Rulemaking 17-09-020
(Filed September 28, 2017)

**WELLHEAD ELECTRIC COMPANY, INC.'s COMMENTS ON
THE CAISO'S DRAFT FLEXIBLE CAPACITY NEEDS
ASSESSMENT FOR 2020**

April 18, 2019

2015 forecast of 2017 3-hour upward ramps vs. actual 2017 3-hour upward ramps

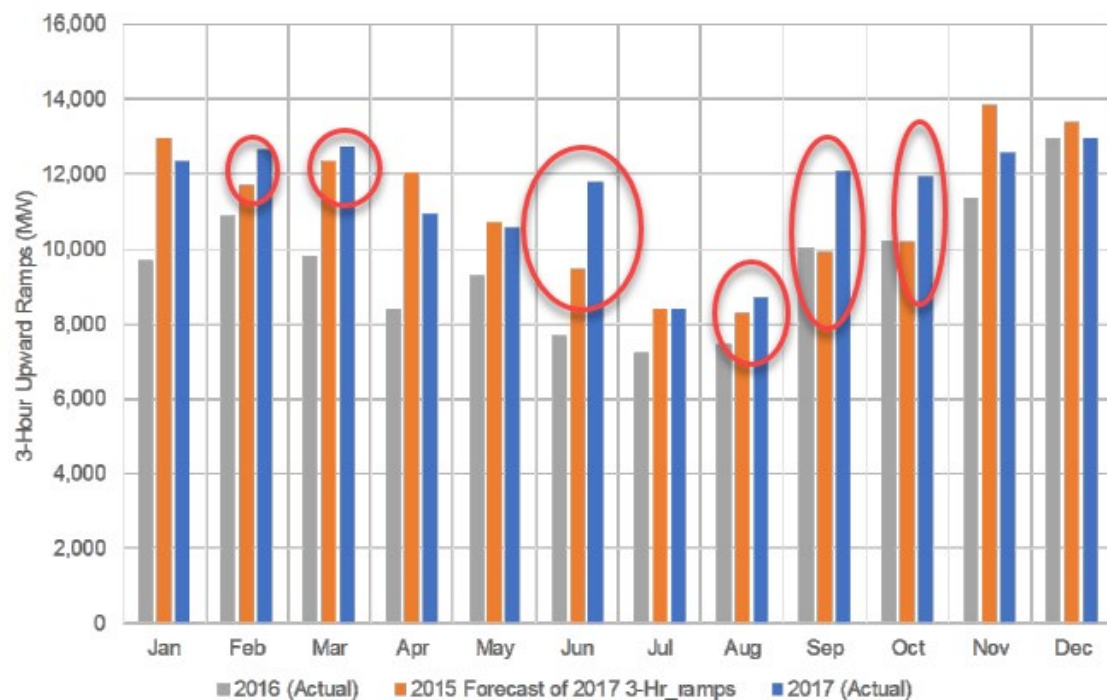
The actual flexible capacity needed in many months (as shown below, with circles added for emphasis²) has exceeded the forecasted need. The point is made that the CAISO should increase the Flexible Capacity Requirements to account for reasonably anticipated forecast errors. This

can be done by giving ϵ^3 (in the Flexible Capacity Requirements formula) a positive value sufficient to account for historical forecast errors. Wellhead suggests using the greatest forecast error of the prior full year to determine the value of “ ϵ ” for the year being forecasted. For example, Wellhead estimates that a deficiency of 1,712MW occurred in August of 2018. Therefore “ ϵ ” would equal 1,712 for purposes of calculating the 2020 flexible capacity requirements.
